TX RX Systems Inc.  
8625 Industrial Parkway  
Angola, NY 14006  
716-549-4700  
Fax: 716-549-4772

This letter is in response to your request for verification of the addition which has been included into the signal booster model number 61-83B-50, FCC ID: EZZ5PI618350, IC ID: 1940A-PI618350. This addition includes an assembly (Fig. 1) added to the backup DC power input terminals to reduce the conducted emissions (referred to as the 30 VDC supply by Ultratech).

Fig.1

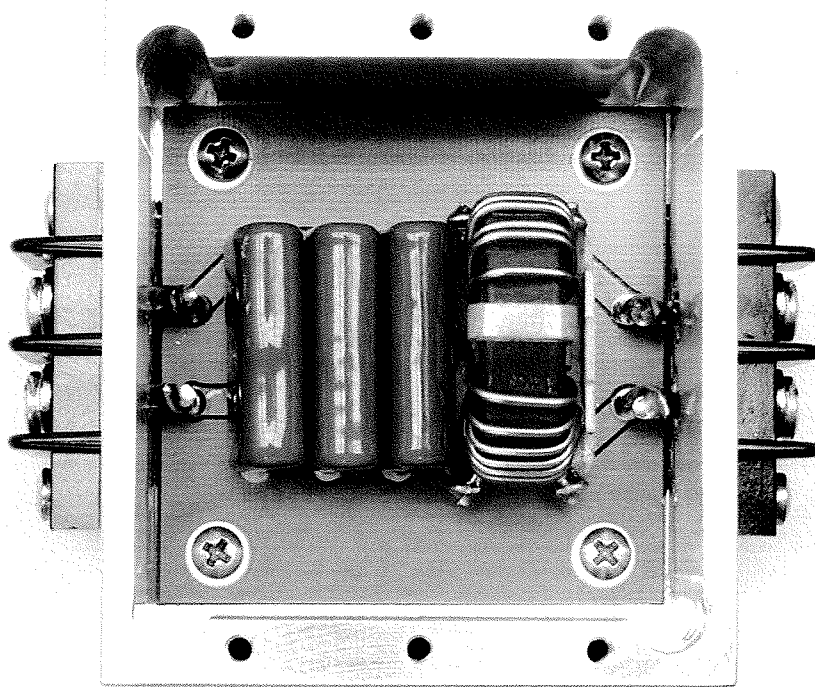
This assembly consists of three capacitors and one inductor. The capacitors are Panasonic part number ECQ-E2225KB, which are 2.2  $\mu$ fd, 250V, metallized polypropylene film, non-polarized. TX RX System has assigned part number 8-20967. The inductor is a JW Miller part number 8108, which is 1mH, 10A inductor. TX RX has assigned part number 8-21128. This assembly has already been added to the bill of materials for this model booster, and will be configured in all of these boosters prior to shipment.
